U-286

To provide SS grating inside 11/21 MV-6

EWRI NO. * 21-288

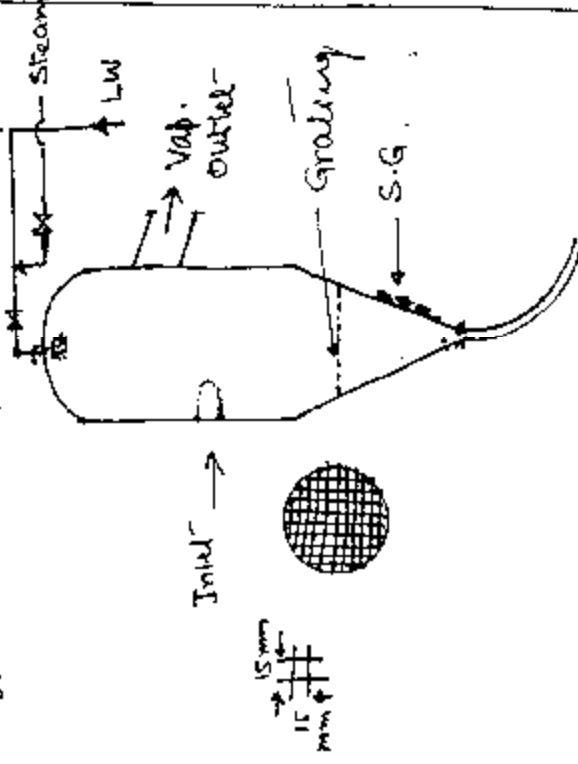
After installation of vacuum pre-concentrator urea concentration to the inlet of first vacuum separator (MV-06) has increased from earlier value of 71 % to 85 %. This is resulting in the formation of polymer inside MV-06. This polymer falls during plant start-up or vacuum section flushing and choke MV-06 to MV-07 transfer line (Lute). Prilling remains diverted for hours in order to dechoke this line. Flushing /dechoking of lute also generates lot of effluent which creates pollution problem. The grating will retain the polymer on it which will subsequently get dissolved in urea solution. Provision of LS connection from nearby 1" steam line into LW line for dome flushing will create flexibility to flush MV-6 dome either by LW or steam. The expected investment of installing grating in MV-6 is about Rs 3 lacs for both units.

To provide (i) stainless steel grating inside

11/21-MV-6 as shown in the sketch.

(ii) Steam connection for flushing
